Docket No. 52-021
MHI Ref: UAP-HF-08141

Subject: MHI's Response to NRC's Request for Additional Information on US-APWR Topical Report MUAP-07010-P, Non-LOCA Methodology

MHI's Response to NRC's Request for Additional Information on
US-APWR Topical Report MUAP-07010-P, Non-LOCA Methodology

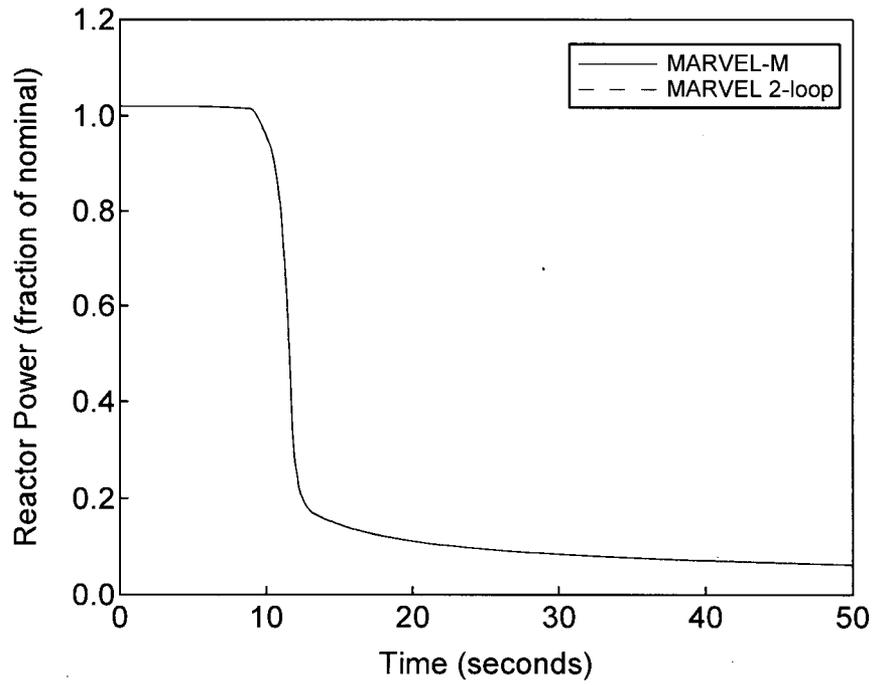
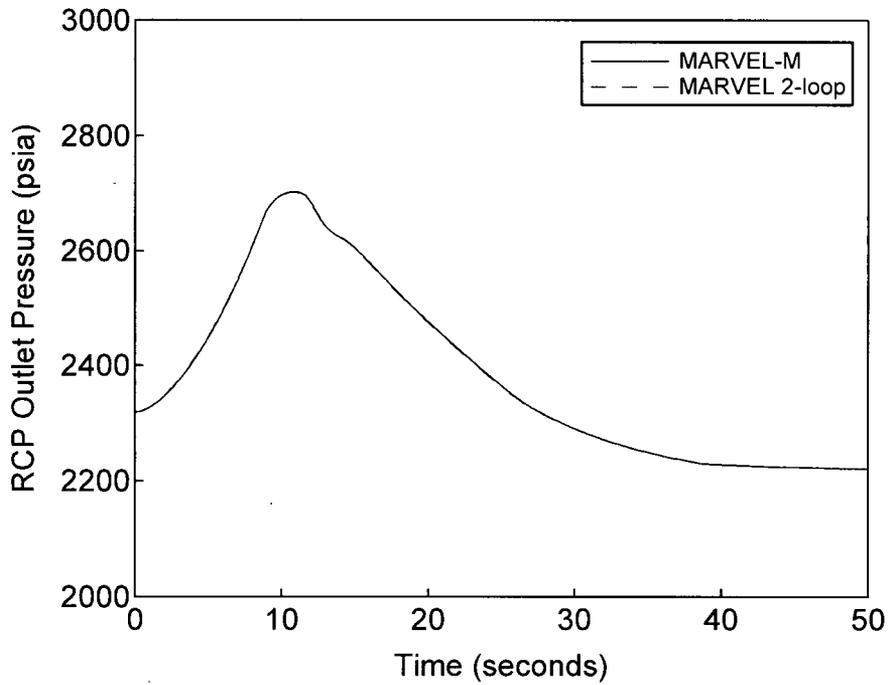
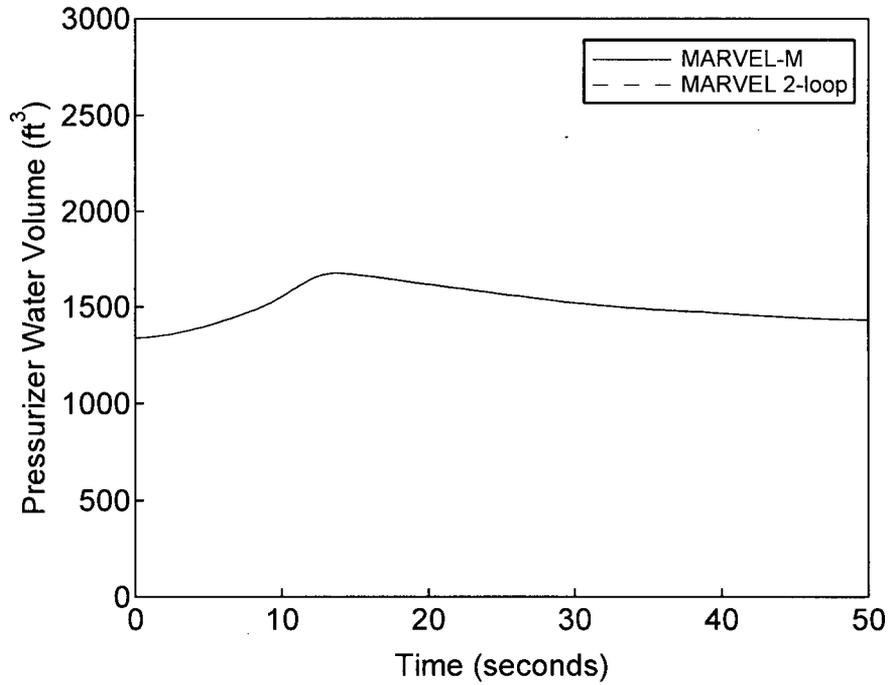
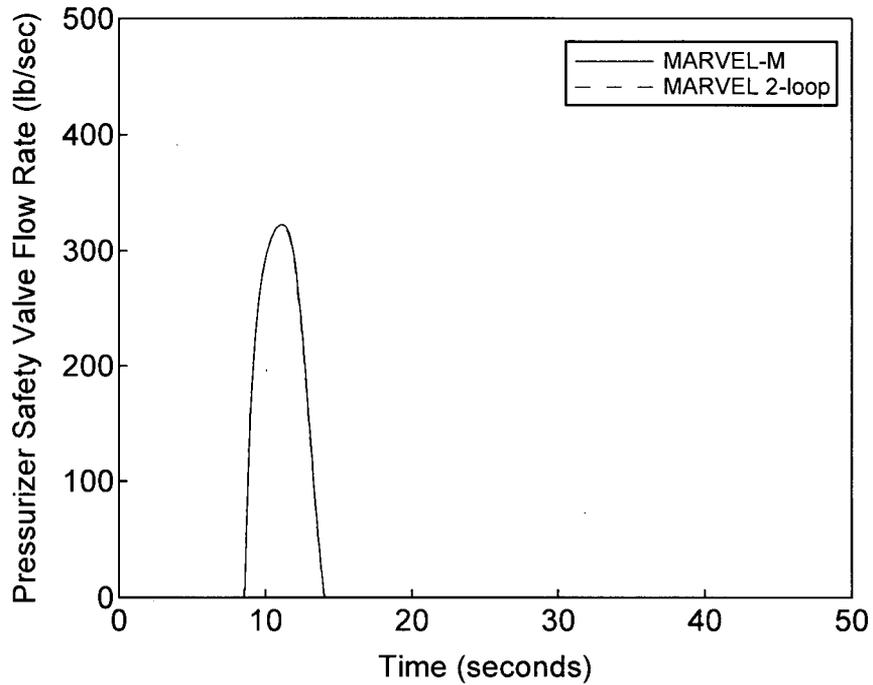
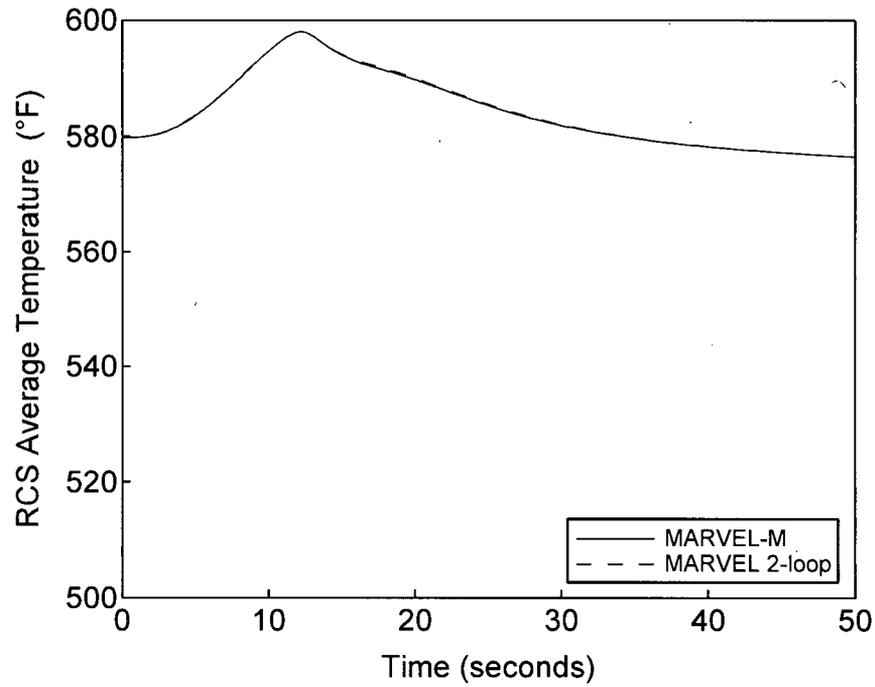
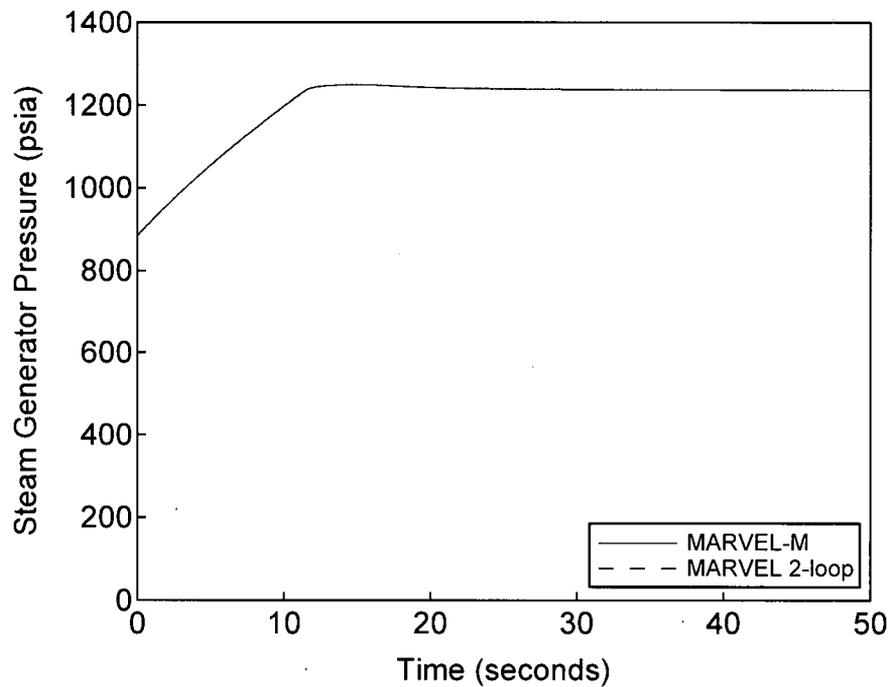
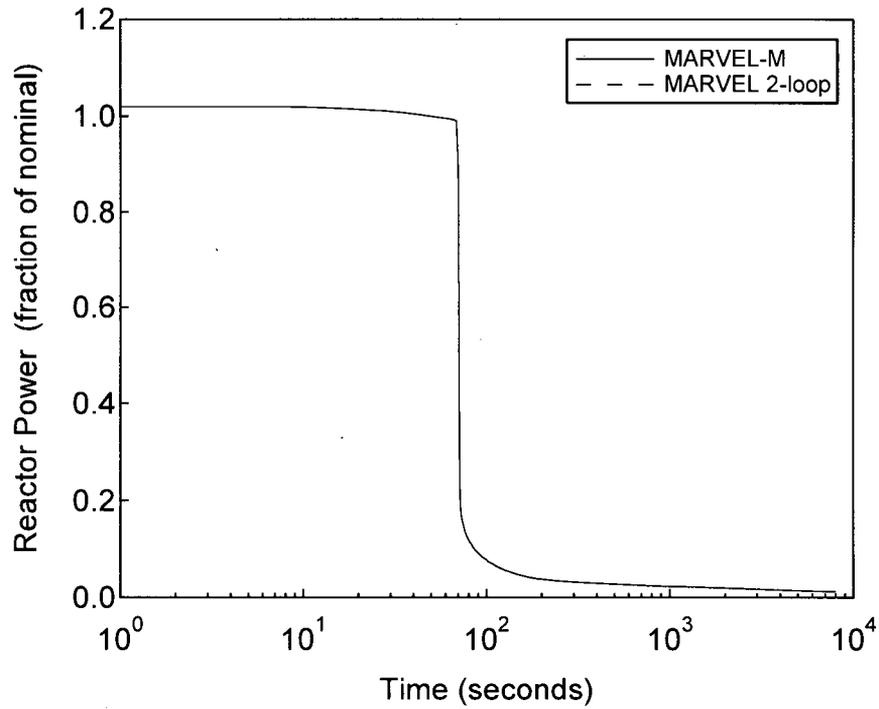
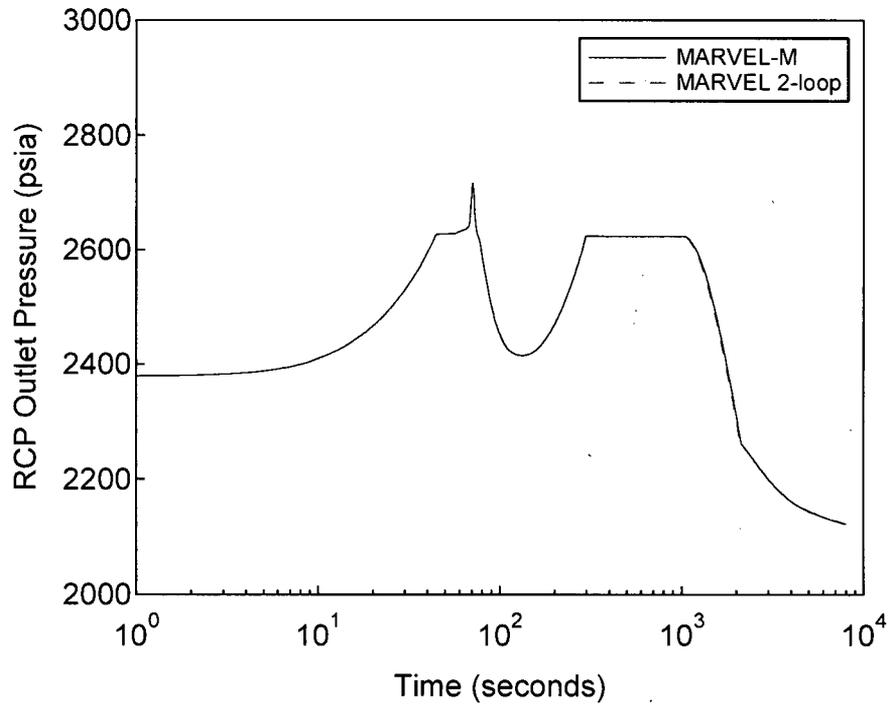
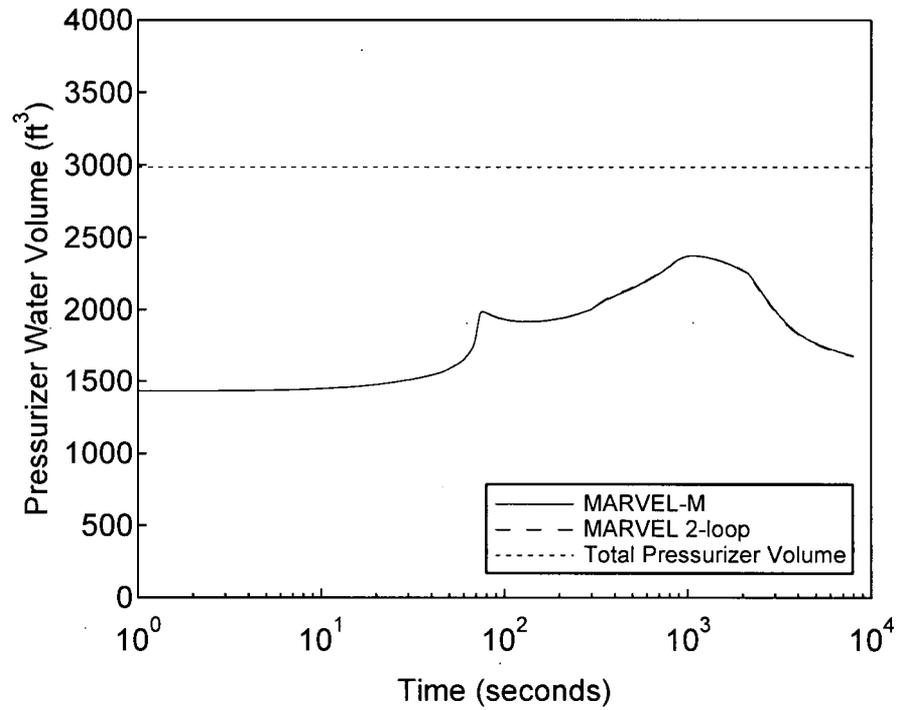
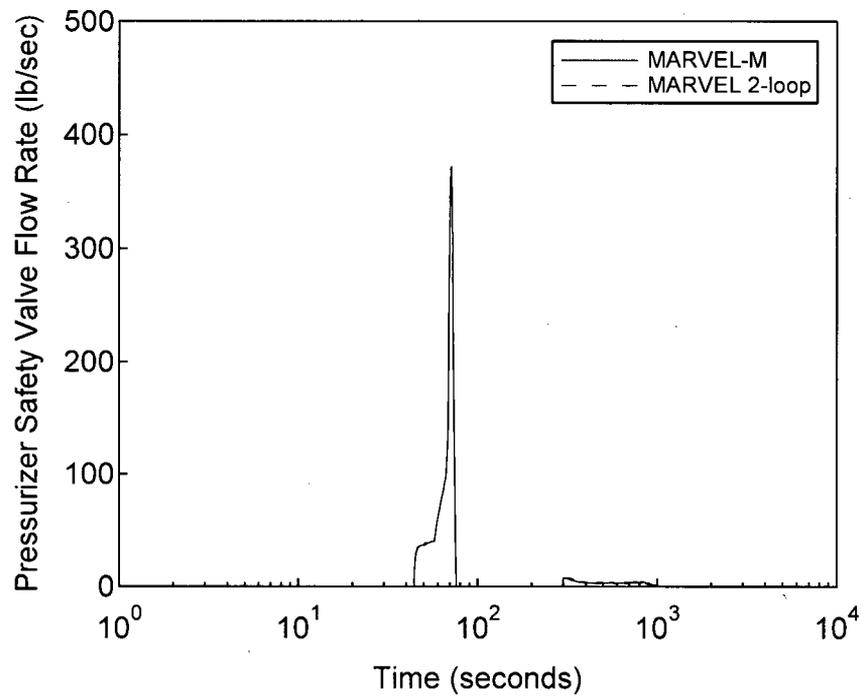
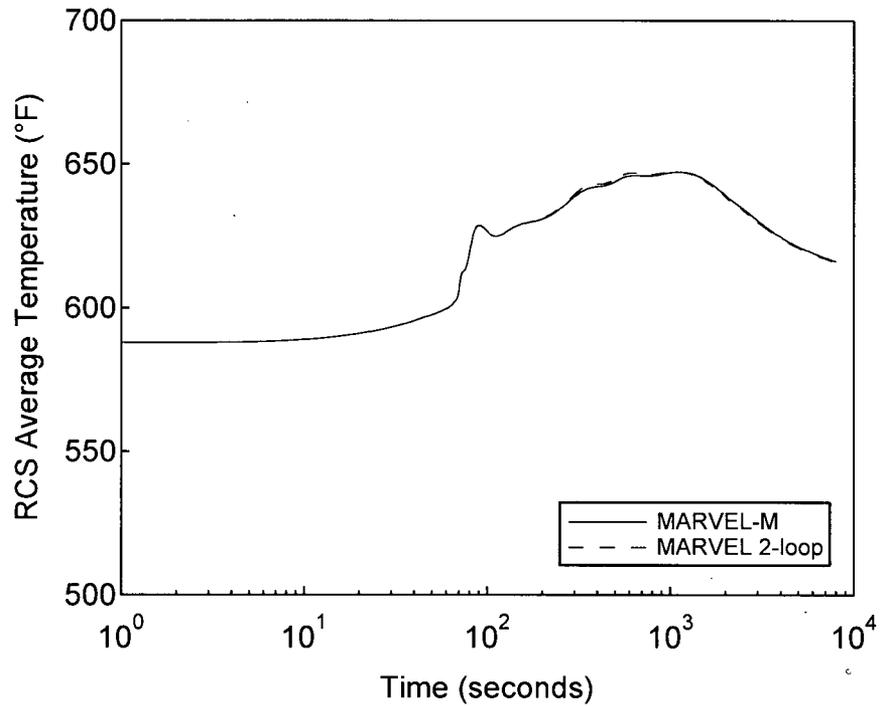
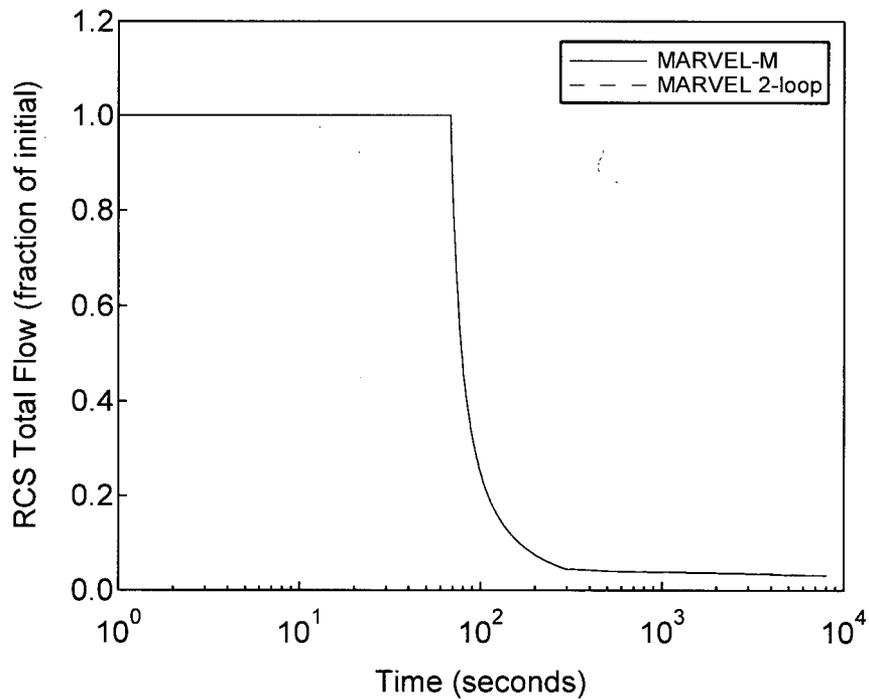
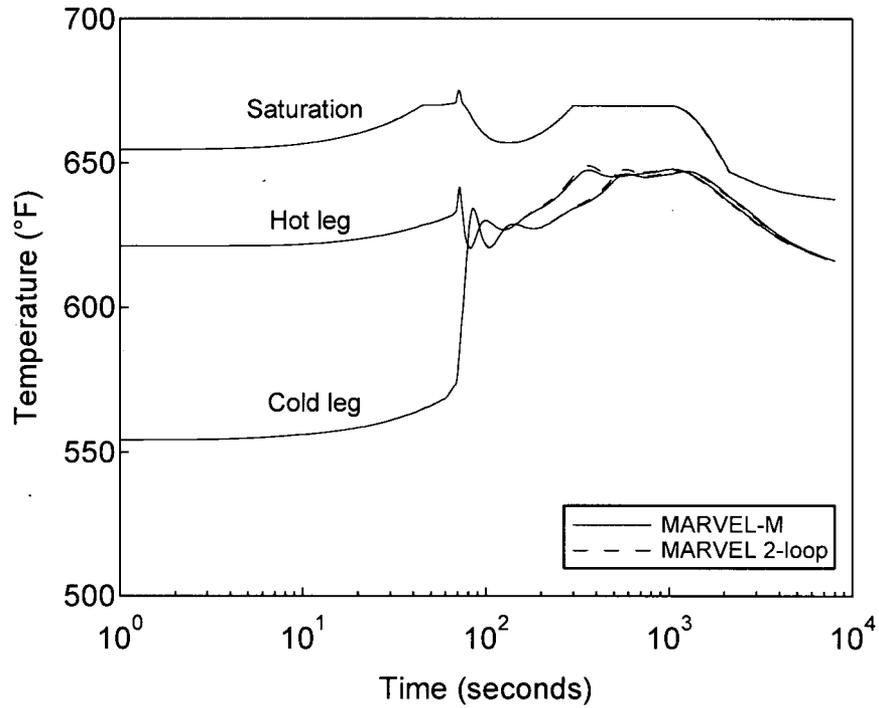
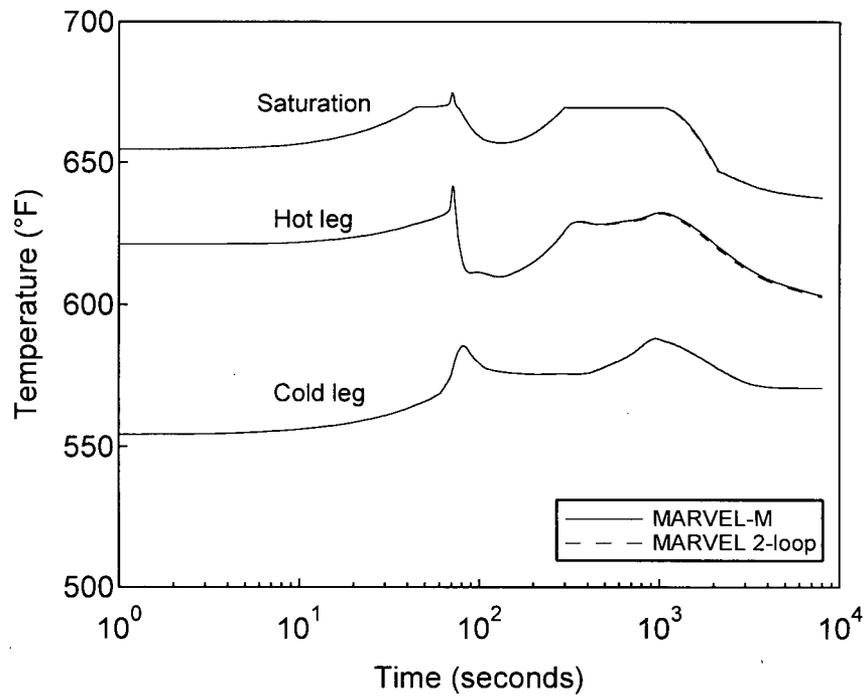
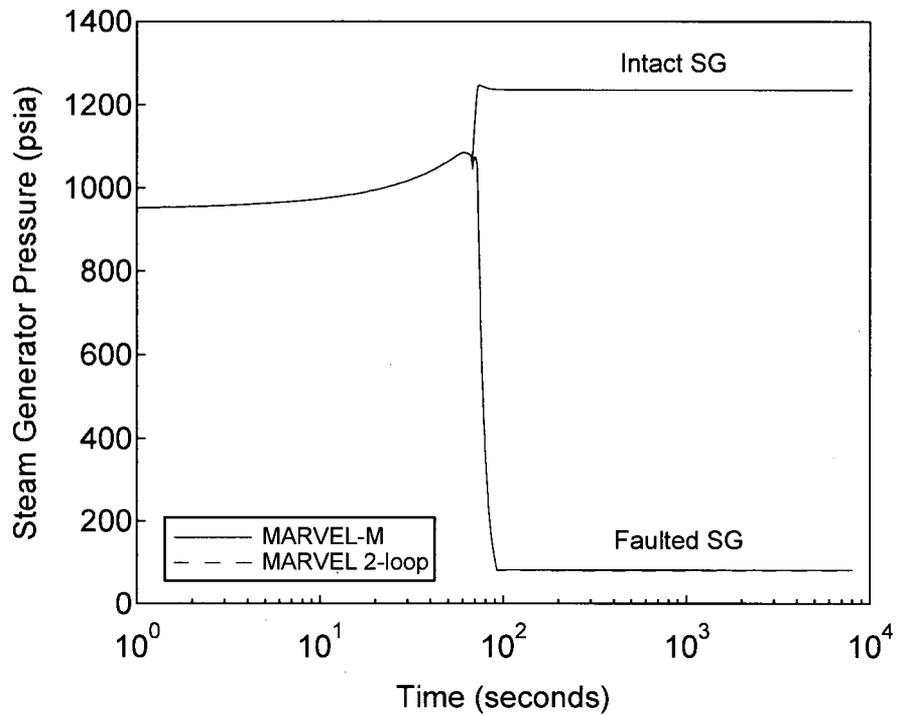
Have any MARVEL/MARVEL-M code comparisons been performed? Please provide a MARVEL/MARVEL-M code comparison for a typical 2-loop calculation.

Comparisons between the MARVEL and MARVEL-M codes have been performed for non-LOCA events as a verification of the extension from a 2-loop simulation to a 4-loop simulation. The results of these comparisons are introduced in the following figures. Figures 2.1-3.1 through 2.1-3.6 show the comparison of "Loss of Load" as a uniform event and Figures 2.1-3.7 through 2.1-3.17 show the comparison of "Feedwater System Pipe Break" as a non-uniform event. The 4-loop MARVEL-M case is set up to assume the break in a single loop with all of the remaining loops receiving the same emergency feedwater flow. This allows a direct comparison with 2-loop MARVEL, which models these loops as a single loop. Both the 2-loop MARVEL and 4-loop MARVEL-M runs utilize the hyperbolic coast down reactor coolant pump model, again allowing for direct comparison of the code output.

The results demonstrate nearly exact agreement between the 2-loop and 4-loop codes for both primary and secondary parameters of interest.
